**Deadline 9** (28 June 2019) – KCC’s response to the ExA’s Fourth Written Questions

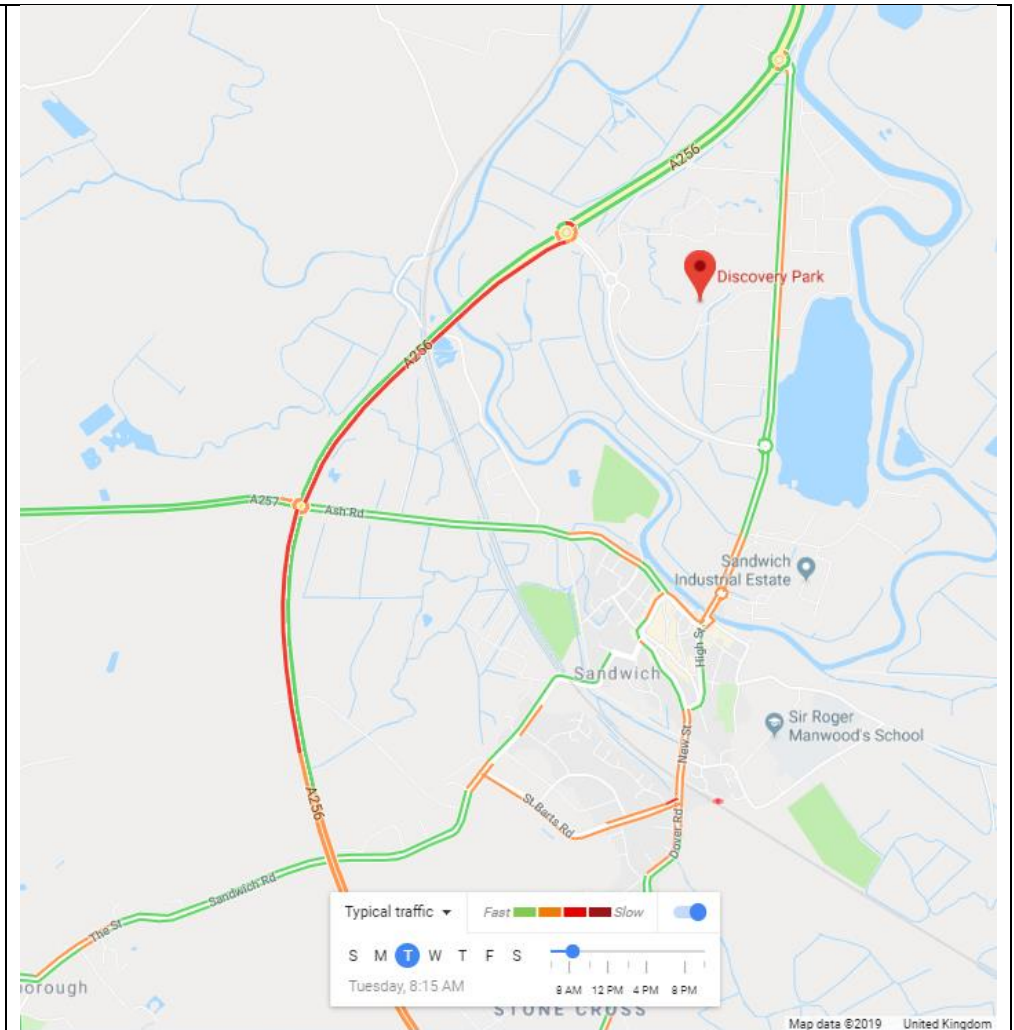
<p>by the Applicant. These include traffic flows entering/leaving the current network study area on:</p> <ul style="list-style-type: none"> <li>• The A256 (177 and 155 two-way traffic movements in the AM and PM peaks respectively).</li> <li>• The A299 Thanet Way at St Nicholas-at-Wade (111 &amp; 84 two-way traffic movements in the AM and PM peaks respectively).</li> </ul> <p>KCC suggested that the study areas should be expanded to better understand potential impact on these links and appropriate mitigation proposals progressed if adverse impacts are identified. After further discussion at the ISH7 on 6 June 2019 [EV-028], the Applicant agreed to undertake a proportional impact assessment on the wider study area. This is presented in the Summary of Applicant's Case put Orally - Traffic and Transport hearing and associated appendices at Appendix ISH7 – 32 [REP8-017].</p> <p><b>i. Is KCC content with the methodology adopted?</b></p> <p><b>ii. Is KCC content with the findings of the additional assessment?</b></p> <p><b>iii. Is the use of a 5% proportional increase threshold appropriate and acceptable to KCC?</b></p>	<p>As outlined by KCC during ISH7, it is not agreed that a blanket 5% impact threshold for additional assessment of junctions is appropriate.</p> <p>Whilst it is accepted that within the industry 5% is generally adopted by consultants and local authorities as a guideline, it is nonetheless important to consider the specific operation of the road network in question and the nature of impact from the development, which has not been done in this case. This is particularly important when the network is already subject to existing traffic delay. On parts of the local road network where junction/link capacity has already been exceeded, a relatively minor increase in traffic movement can result in disproportionate worsening of existing delay. This has been highlighted on other junctions within the scope of the Transport Assessment (for example Junction 26 &amp; 27)</p> <p>Parts of the A256 corridor within Dover are already subject to extended queuing and delay (this is demonstrated by the traffic extract below which is taken from Google Maps). In this case, the primary area of interest to KCC is the A257/A256 roundabout junction. The Applicant has not provided sufficient information for the KCC to reach an informed decision regarding traffic impact at this junction and consequently determine if further mitigation is required.</p>

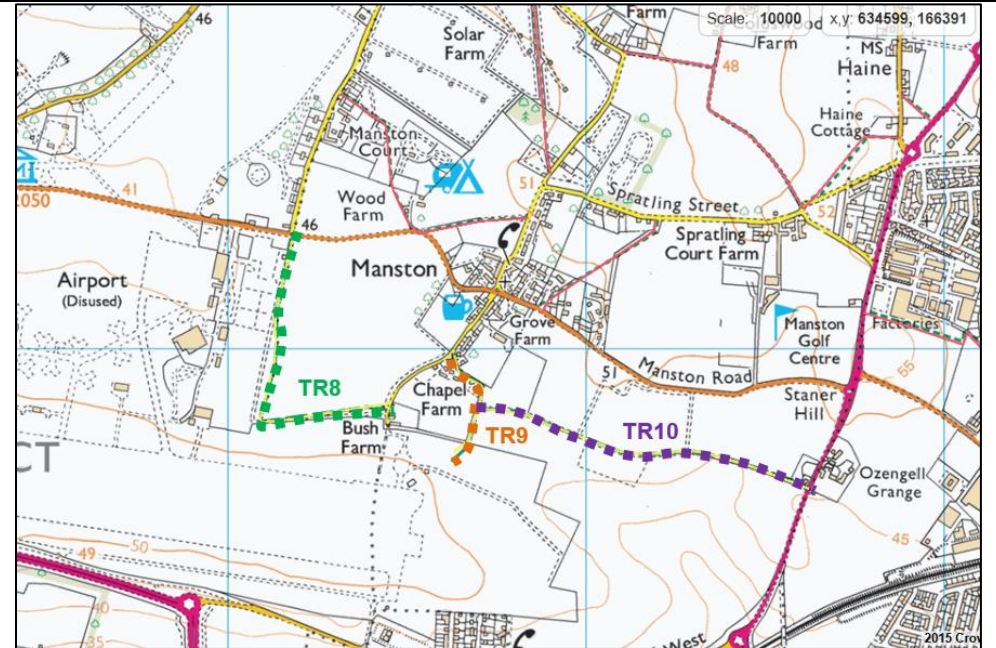
*“The population of Manston is small (100 houses or less), and the potential usage by residents of a footway alongside the B2050 from the village to the Airport is limited. The improvement of TR10 has the potential to attract higher usage as it will provide a connection to the Manston Green development, comprising 800 homes, as well as Manston Village and the western outskirts of Ramsgate”.*

**i. Does this overcome the concerns of KCC with regard to pedestrian links with Manston Village?**
